November 12, 2021

PCN1098: Product Change Notification for Littelfuse Discrete SOT-227B package – Introduction of Laser Marking in Portugal Assembly Location

Figure 1: INKJET marked SOT-227B (old)

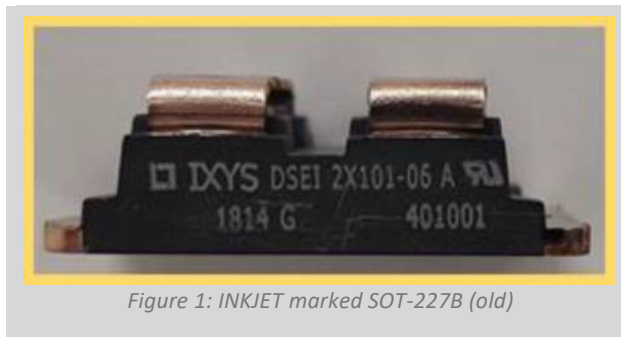
DESCRIPTION OF THE CHANGE: Starting from December 1st, 2021 the marking of the SOT-227B package will change from inkjet marking to laser marking. A comparison can be seen in **Figure 1** and **2**:
